From: Mike Hager on behalf of Mike Hager <mhager@AHBL.com>
To: Eatch Beck - Capital Projects
Cc: Nick Rheaume
Subject: RE: 20190122 - CKHSMS CDC 130 - Soule RD connection (003).pdf
Date: Wednesday, January 30, 2019 10:59:07 AM
Attachments: image001.png
image002.png

From: Eatch Beck - Capital Projects [mailto:BeckE@ckschools.org]
Sent: Wednesday, January 30, 2019 10:27 AM
To: Mike Hager
Cc: Eatch Beck - Capital Projects; Nick Rheaume
Subject: 20190122 - CKHSMS CDC 130 - Soule RD connection (003).pdf
Importance: High

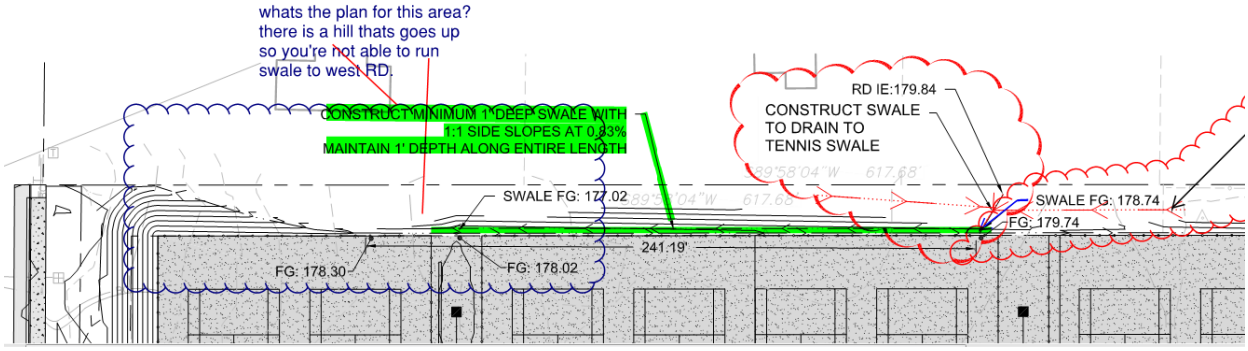
At the west end of the tennis courts the elevation goes up it appears that this solution might pond the water further down the tennis courts.

They will need to regrade along the entire length of the tennis courts until it drops down the hill/swale. The exhibit has the note "CONSTRUCT MINIMUM 1' DEEP SWALE WITH 1:1 SIDE SLOPES AT 0.83%. MAINTAIN 1' DEPTH ALONG ENTIRE LENGTH". This note is pointing out the swale that was already a part of the plans, but was never constructed. This swale will need to be constructed in order for the area to drain.
